Access Compliance Report

Public Rights-of-Way

| Intersection ID: 28189 | Main Street: DARBY_CHASE_DR | Cross Street: JAMES_RICHARD_DR | Location: SW |
| ADA ID: E14EEE280D49 | Ramp Type: Perp | Initial Pass/Fail: Fail | Overall Compliance: No |

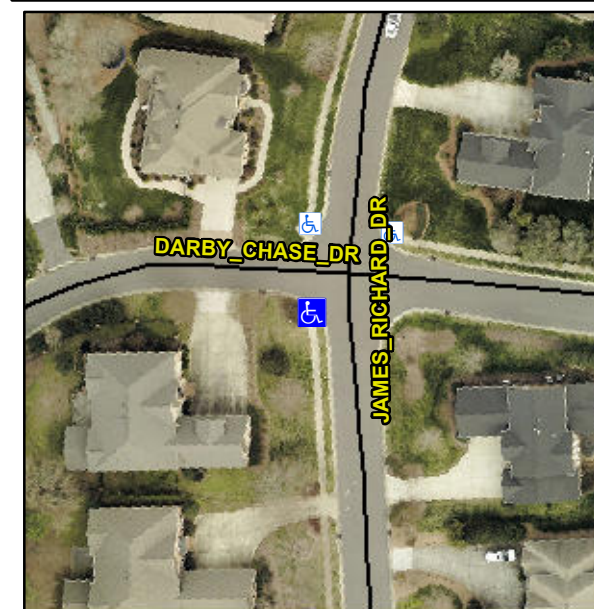
R304.5.1, R304.5.3

| Compliance | Description | Data | Compliance | Description | Data |
|------------|-----------------------|------|------------|-----------------------------|------|
| N/A | Ramp Length (in) | 48.0 | Yes | Ramp Slope (%) | 5.7 |
| No | Ramp Width (in) | 38.0 | No | Ramp XSlope (%) | 2.1 |

Remove & Replace Entire Ramp.
